Re: Call Sign E080100: Applications of Row 44, Inc. for
Authority to Operate up to 1,000 Technically-Identical Aeronautical-Mobile
Satellite Service Transmit/Receive Earth Stations Aboard Commercial and Private
Aircraft, FCC File Nos. SES-LIC-20080508-00570; SES-AMD-20080619-00826;
SES-AMD-20080819-01074; SES-AMD-20080829-01117;
Special Temporary Authority, FCC File No. SES-STA-20080711-00928; and
Special Temporary Authority, FCC File No. SES-STA-20080811-01049.
Notice of Ex Parte Presentation

Key Technical Issues With Row 44 Application

FIGURE 4.1.2-4 Antenna Gain in dBi for 14.05 GHz (Horizontal Polarization)
(25.209 Expanded Azimuth)

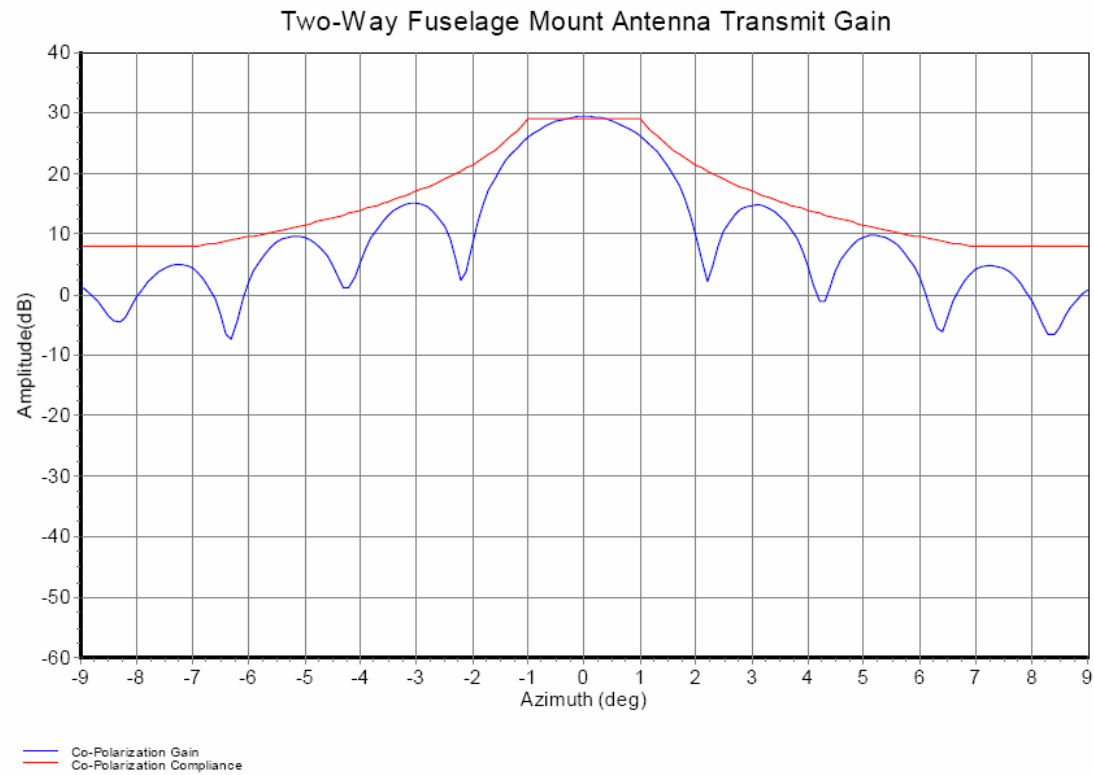
- **Row 44 proposes to inhibit transmit if “Skew Angle” exceeds $\pm 25^\circ$**
 - This $\pm 25^\circ$ limit is apparently intended to ensure that the elevation pattern (which does not comply with Section 25.209) comes no closer than 65° to the GSO plane
- **Transmissions would be inhibited at angles greater than $\pm 25^\circ$ to prevent higher than allowed off-axis EIRP density signals in the direction of adjacent satellites due to the wide elevation pattern impinging on the GSO plane**
- **The choice of a $\pm 25^\circ$ limit by Row 44 assumes that the rest of their system meets FCC requirements**
- **Pointing error and uplink power control error would impact off-axis EIRP density, necessitating a reduced value for “Skew Angle”**

View of GSO from AES

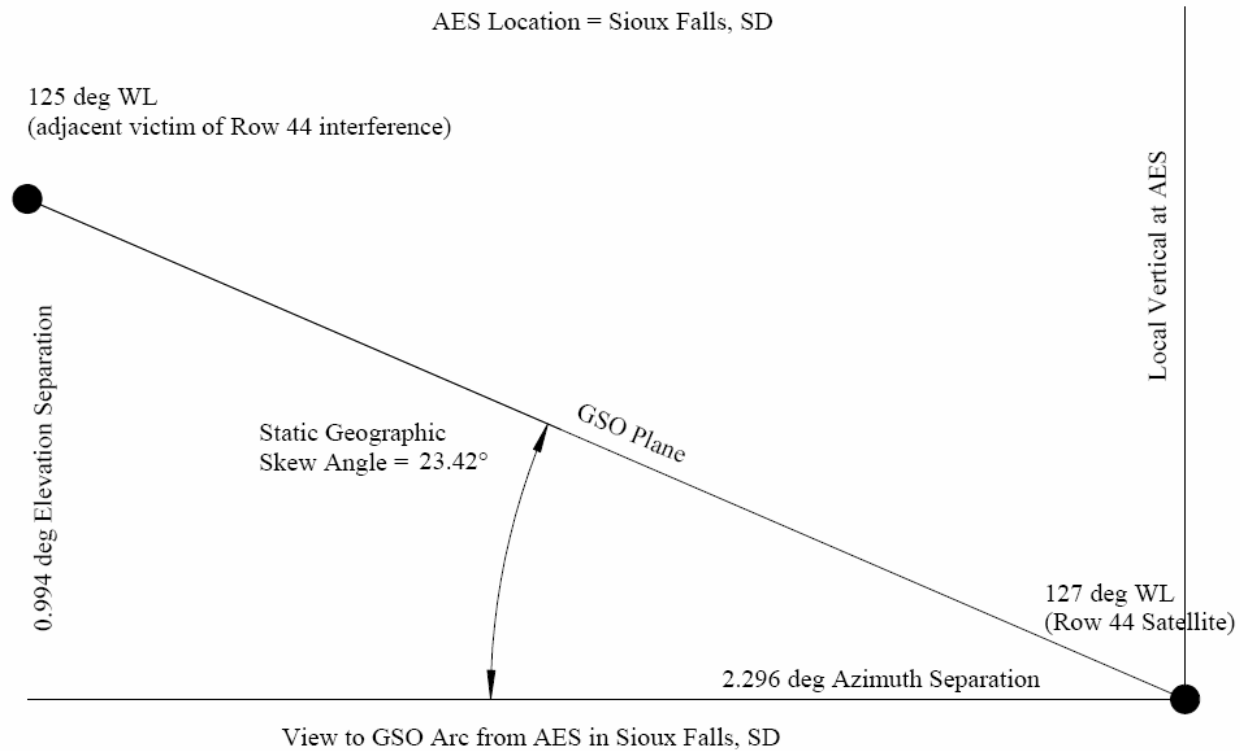
- **Row 44 does not discuss the effect of aircraft banking on the alignment of antenna azimuth and elevation axis**
- **In level flight, the elevation axis of the antenna is vertical and perpendicular to the GSO plane when the aircraft is due North of the operating satellite**
- **When the aircraft banks, the elevation antenna pattern will be tilted with respect to the GSO plane depending upon the direction of the turn because the AeroSat antenna does not have a mechanism to adjust for this tilt**
- **Depending on the direction of the bank, the tilt will either add or subtract to the geographic skew**
- **Bank angles of up to 30° are common on commercial airliners**
- **In the following discussion, the bank angle will be assumed to be toward the victim satellite and additive to geographic skew**

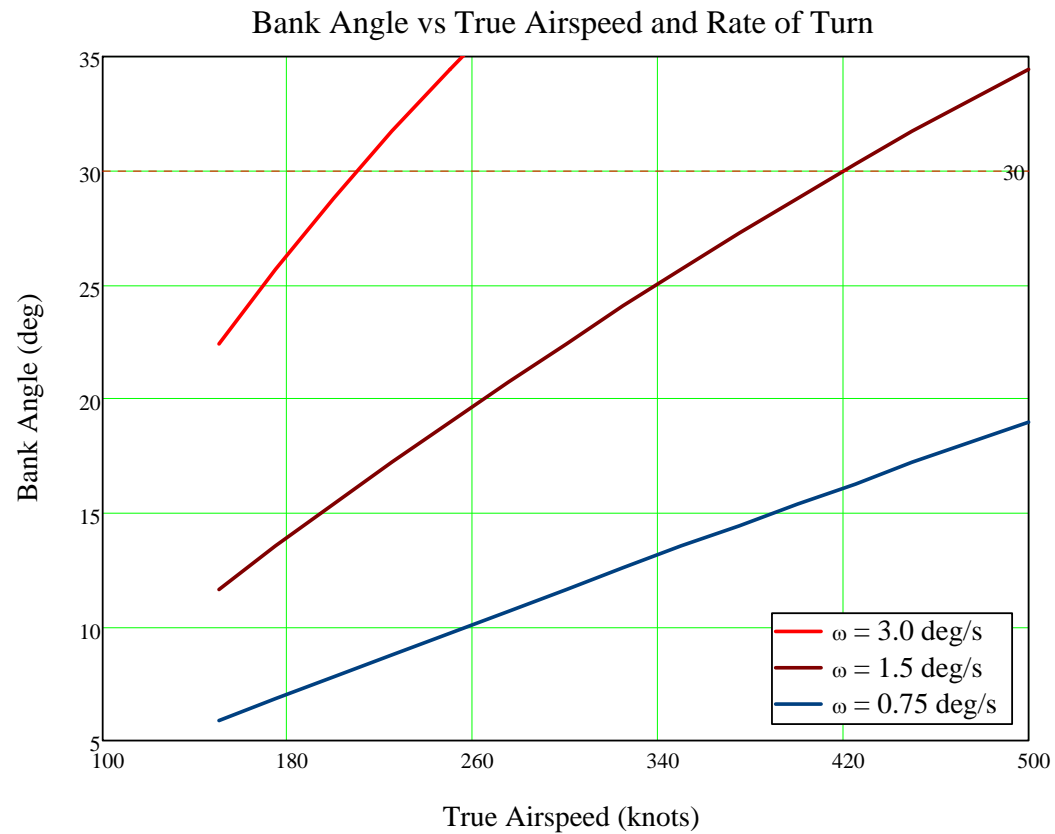
- **Commercial aircraft follow Instrument Flight Rules (IFR)**
- **A keystone of IFR flight is the standard rate turn**
 - Turn rate is 360° per 2 minutes (3° per second) below 250 knots commonly, and half that (1.5° per second) at higher speeds
- **Aircraft follow Air Traffic Control (ATC) flight corridors which are designed with specific turn radius and true airspeed (TAS) in mind**
- **Bank angle for a level coordinated turn is a physical function of rate of turn, velocity, and gravity**

- **30° bank is only 1.15 G – not objectionable to passengers**
- **G-force is a function solely of bank angle:**

FIGURE 5-5 North American Coverage Using Horizons 1 Satellite

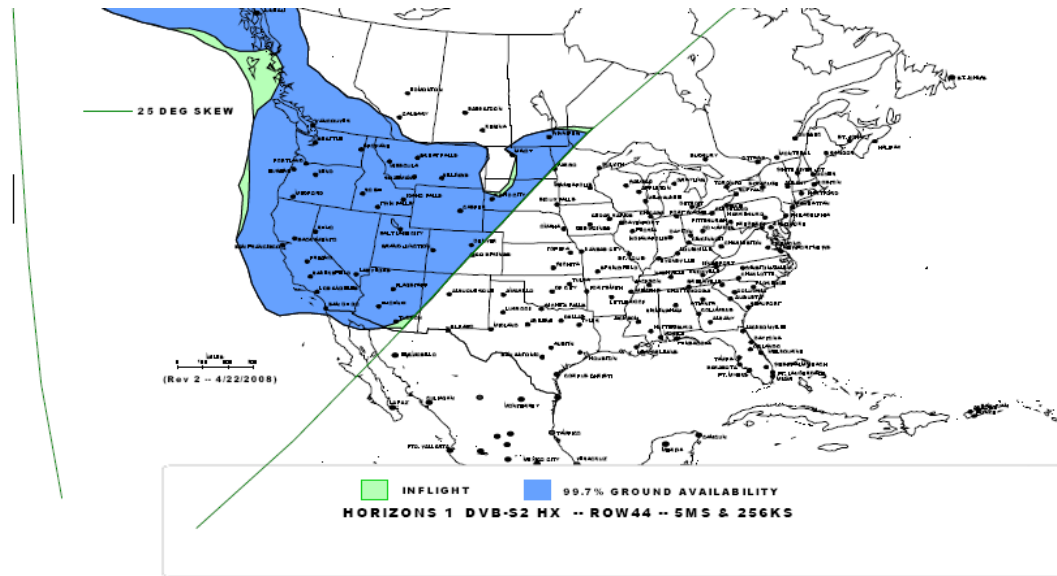
- **In the Google Earth picture, zones depicting the $\pm 5^\circ$ skew limits are shown for each satellite**
- **Within the zones, banks of up to 25° could occur at 0° skew and only 20° at the edge of the zones**
- **Outside the zones, the allowable bank angle decreases with skew to 0° when skew reaches 25°**
- **Bank angles $> 30^\circ$ are never allowed**
